Access Compliance Report

Public Rights-of-Way

(Pedestrian Signals)

Intersection ID: N/A	Main Street:	Cross Street: N/A	Location: N/A
ADA ID: 84F2BF8311D0	Signal Type: One Push Button-APS	Overall Compliance: No	Severity Score: BTN 1: N/A BTN 2: N/A No BTN: N/A
Codes/Mitigation Info/Possible Solution		Field Measurements/Component Compliance

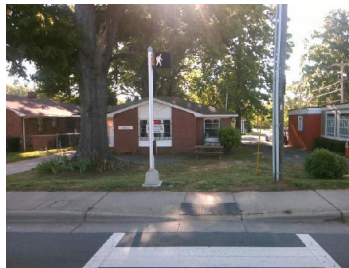
PROW/ADA: R404.3, R404.2, R404.7.3,
R209.1, MUTCD 4e.10

Possible Solutions: Remove & Replace
Replace APS Button With New APS Button.
Provide PAR As Indicated. Remove and
Replace Clear Space.
